ONTARIO ENERGY BOARD

AND IN THE MATTER OF an Application by Milton Hydro Distribution Inc. under Section 78 of the OEB Act to the Ontario Energy Board for an Order or Orders approving or fixing just and reasonable rates and other service charges for the distribution of electricity as of January 1, 2023.

**INTERROGATORIES
FROM THE
SCHOOL ENERGY COALITION**

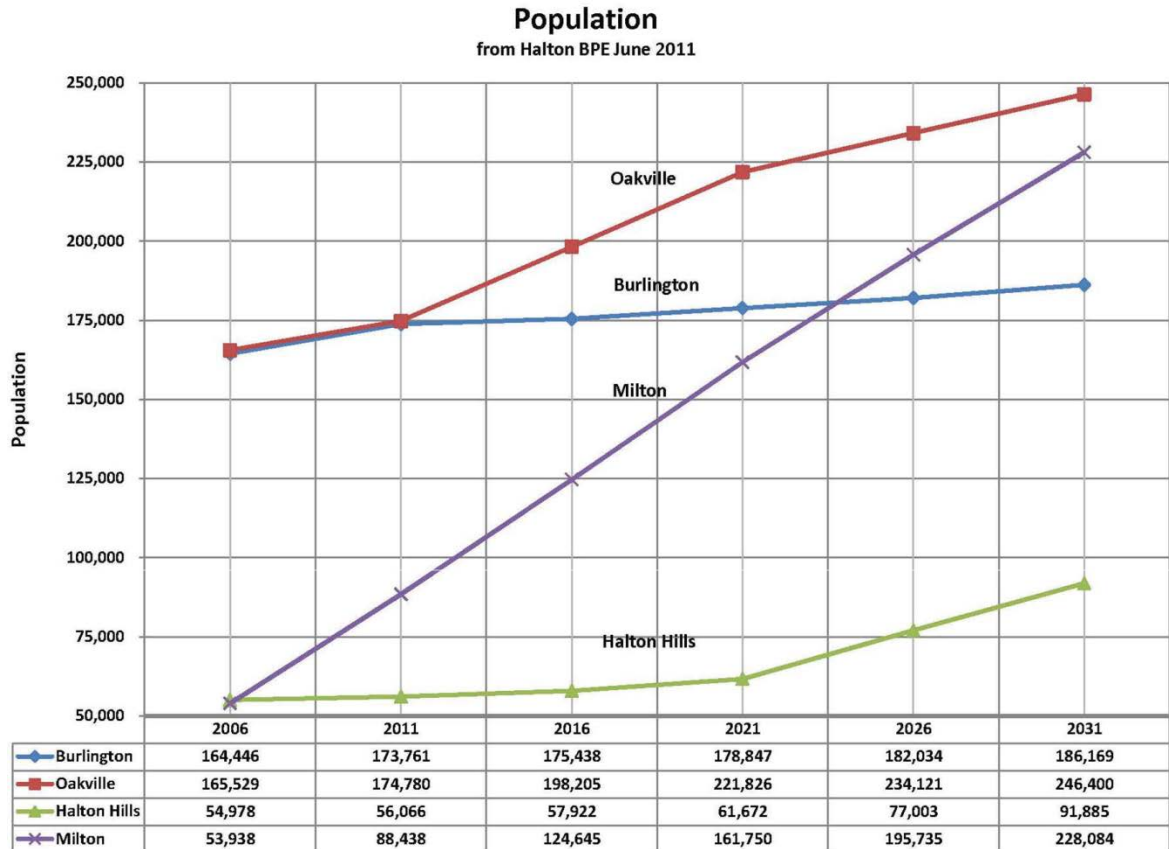
[Exhibit 1, p. 9, 98] The Application describes in some detail the shift in goals from being a “low-cost distributor” to being a “larger-sized distributor”:

- a) Please confirm that this means de-emphasizing the former goal of being “low-cost”.
- b) Please quantify if possible the cost savings that the Applicant believes have to be set aside in order to achieve this shift.
- c) Please identify stakeholder input that supports this shift.
- d) Please quantify the improved outcomes customers will experience as a result of de-emphasizing the low-cost goal.

Load Growth in Milton

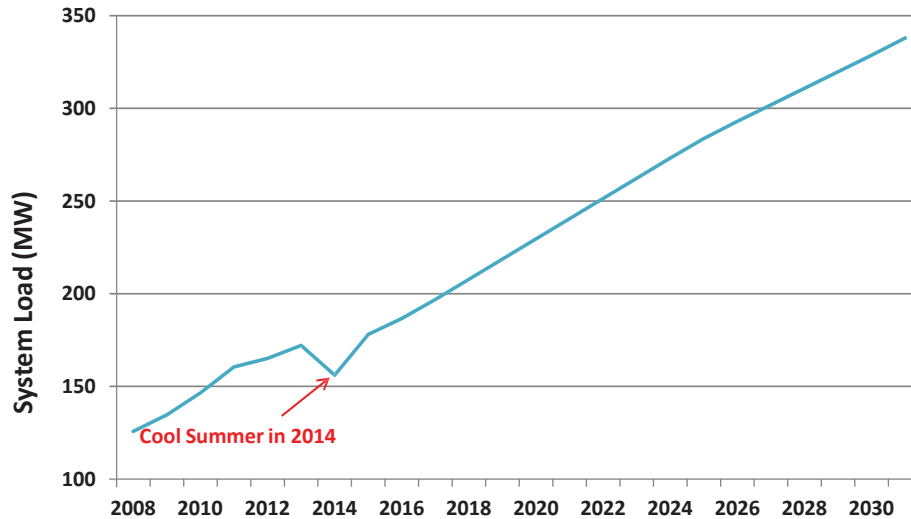
- a) Please confirm that the following chart is Slide 16 from Milton Hydro’s presentation to the OEB in EB-2015-0089.

- b) Please reconcile the chart with Table 1-10.
- c) Please re-do the chart using actuals to 2021, and the current forecast for all subsequent years.
